Title: Class 1 Permit Modification Notification Addition of Structures within
Technical Area 54, Area G, Pad 11, Dome 375 Los Alamos National
Laboratory Hazardous Waste Facility Permit, July 2012

Subject: Notification of Class I Permit Modification for the Los Alamos National Laboratory (LANL) Hazardous Waste Facility Permit to Add Structures to a Container Storage Unit, EPA ID # NM0890010515

**Class 1 Permit Modification Notification Addition of Structures within
Technical Area 54, Area G, Pad 11, Dome 375**

ENV-RCRA-12-0163

Figure 36: TA-54, Area G, Pad 11

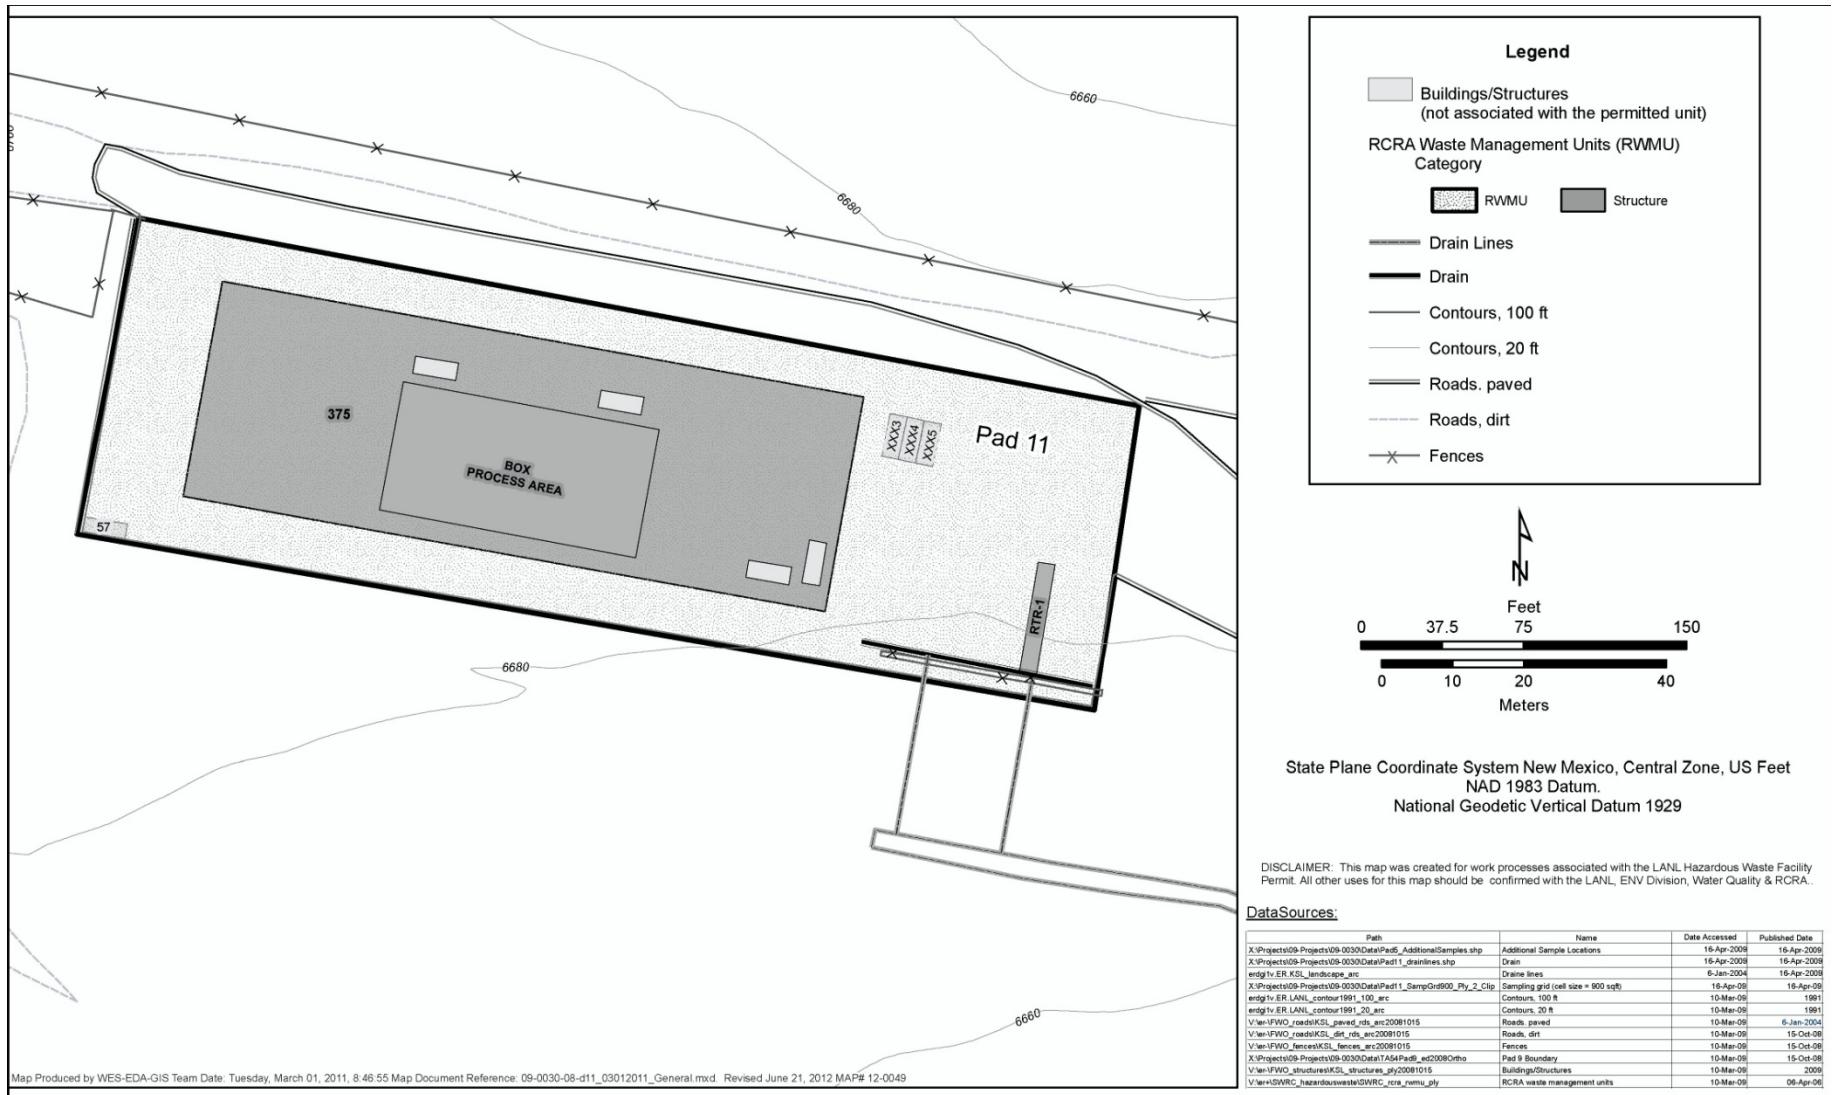
The modification adds structures to the container storage unit at Technical Area (TA) 54 Area G, Pad 11. Structures that will not be used to manage hazardous waste have been added within Dome 375 located at TA-54, Area G, Pad 11.

Descriptions of the structures have been added to Section A.4.2.9 in Attachment A, *TA – Unit Descriptions*; and Section 2.0 in Attachment G.12, *Technical Area 54, Area G, Pad 11 Outdoor Container Storage Unit Closure Plan*. Revised figures are Figure 36 in Attachment N, *Figures*; and Figure G.12-1 in Attachment G.12, *Technical Area 54, Area G, Pad 11, Outdoor Container Storage Unit Closure Plan*.
